HIGHWAY WORK PROPOSAL

Proposal Number: **035**

<u>COUNTY</u>	<u>STATE PROJECT</u>	<u>FEDERAL</u>	<u>PROJECT DESCRIPTION</u>	<u>HIGHWAY</u>
Barron	8317-00-70	N/A	T Clinton, 17th Avenue; Hay River Bridge B-03-0207	LOC STR
Barron	8328-00-70	N/A	T Prairie Farm, 9 1/2 - 10 1/2 St; Doritty Creek Bridge B-03-0208	LOC STR
Barron	8333-00-70	N/A	T Sumner, 28th Street; Br Rock Creek Bridge B-03-0209	LOC STR

Addendum No. 01
 ID 8333-00-70
 Revised Sheet 25
 February 6, 2020

CROSS SECTION
 & QUANTITIES
 SHEET 2 OF 8
 25

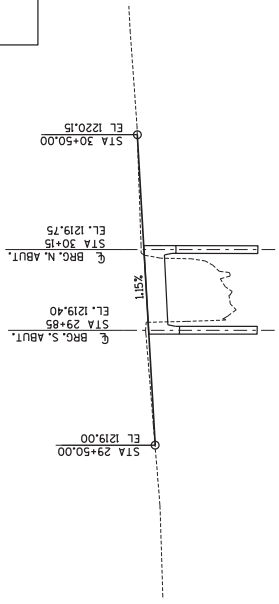
Revised Plan Sheets	
Plan Sheet	Plan Sheet Title (brief description of changes to sheet)
24	Foundation Data
25	Cross Section & Quantities, Structure B-03-0209 – Removed 550.0200. Revised 550.1100
27 – 28	Adjusted Pile length

NO.	DATE	REVISION	BY
1	2/6	REMOVE PRE-BORING	MJG

PILE LAYOUT

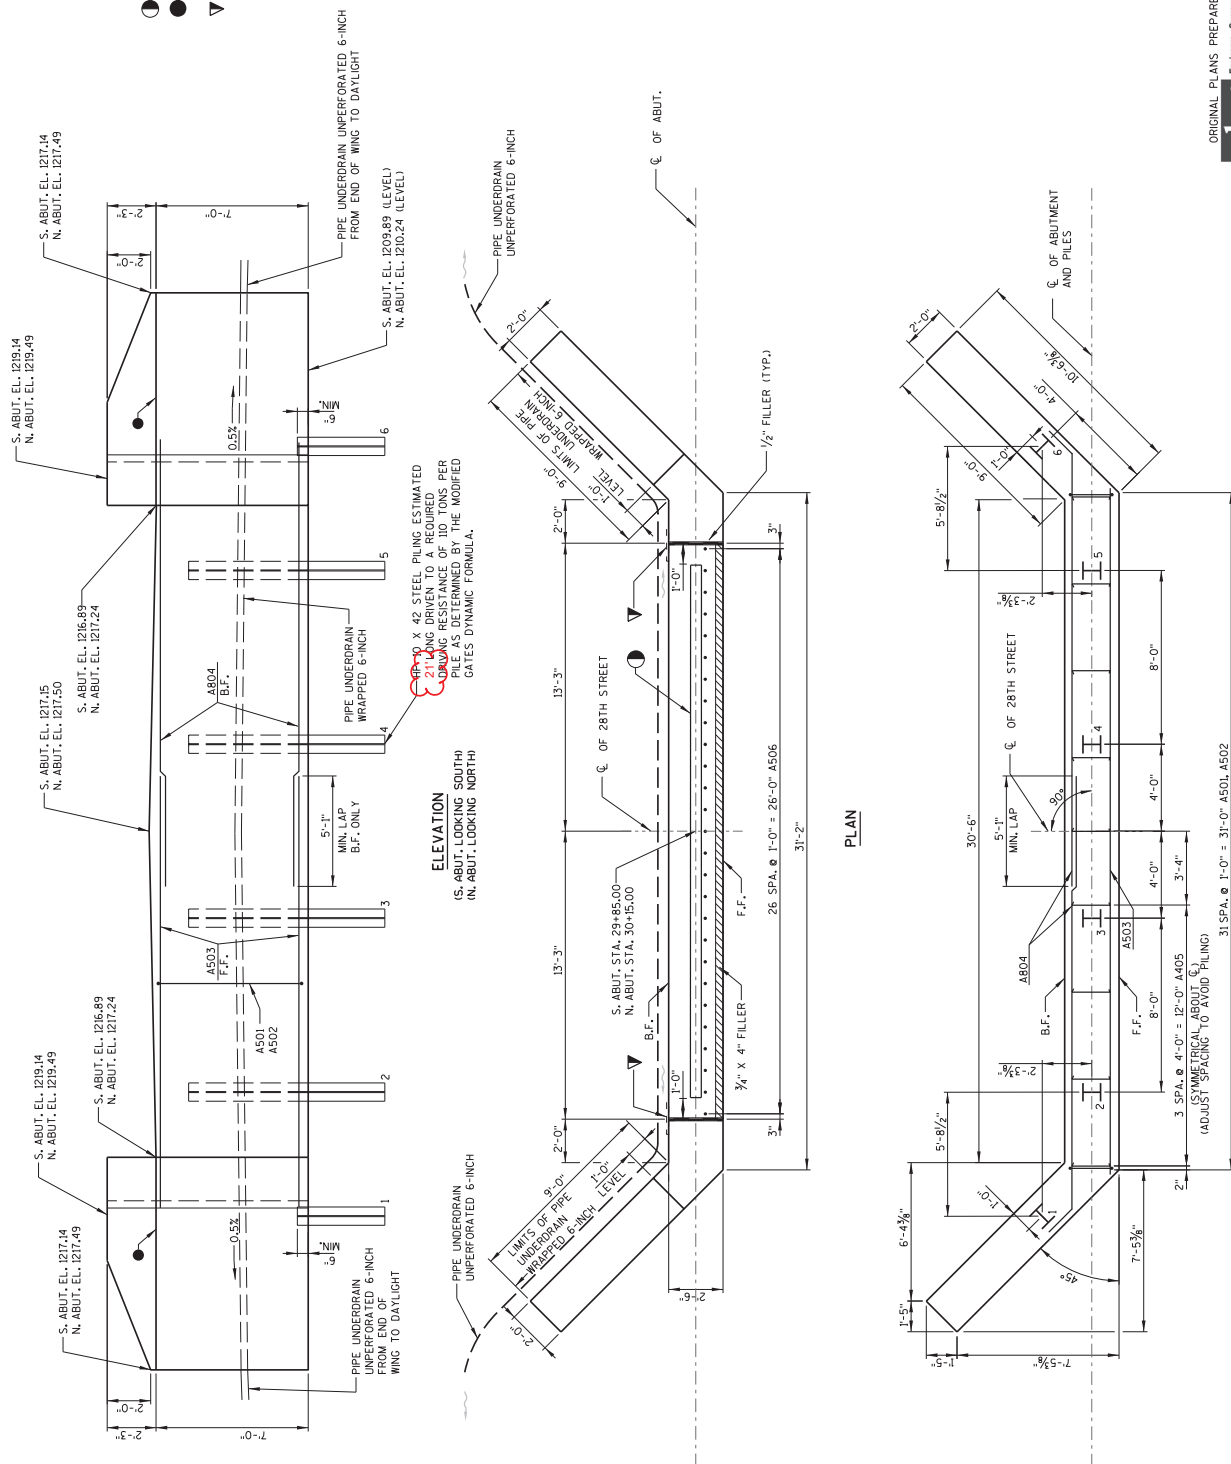
NO.	DATE	REVISION	BY
1	2/6	REDUCE PILE LENGTH	MJG
STATE OF WISCONSIN DEPARTMENT OF TRANSPORTATION			
STRUCTURE B-03-0209			
DRAWN BY: JAS CHECKED BY: MJC			
ABUTMENT ELEVATION DETAILS			
SHEET 4 OF 8			
27
